Memo to Commissioners – Te Ara Tipuna

SUBJECT: Minute 1 & Directions of Hearing Commissioners – requests for further information, Te
Ara Tipuna

RE: Technical Review of Te Ara Tipuna Application – Stage 1

RE: Te Ara Tipuna Trail - Landscape Architectural Peer Review

Example of Concept Plan from CMP where conceptual detail is similar to accepted standard

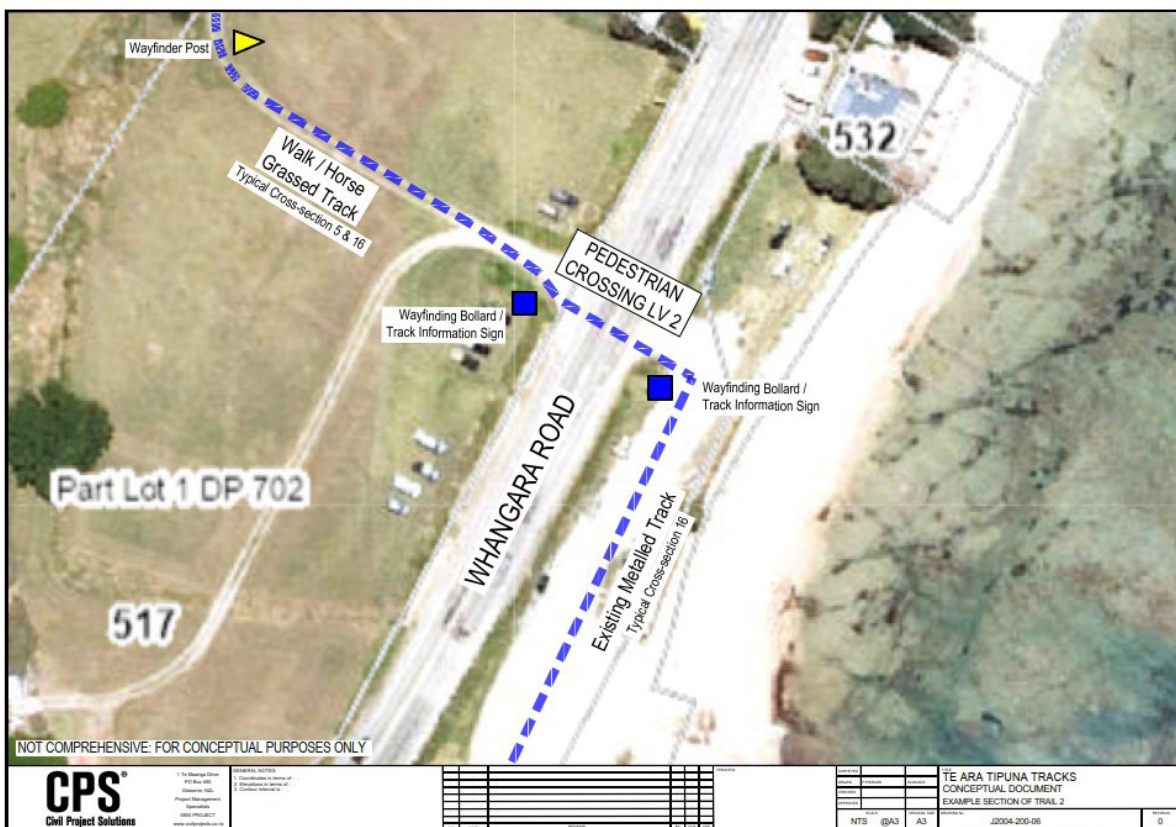
It is requested that the applicant submit Landscape Concept Plans to a similar standard as the example plans submitted within the CMP for the full length of trail to enable comprehensive landscape assessment of the trail.

Currently submitted GIS plans, require the viewer to assume what the design of the proposed path might be at any particular point. This appears to be best achieved by looking at the underlying aerial. However it is not always possible to discern sufficient detail from this.
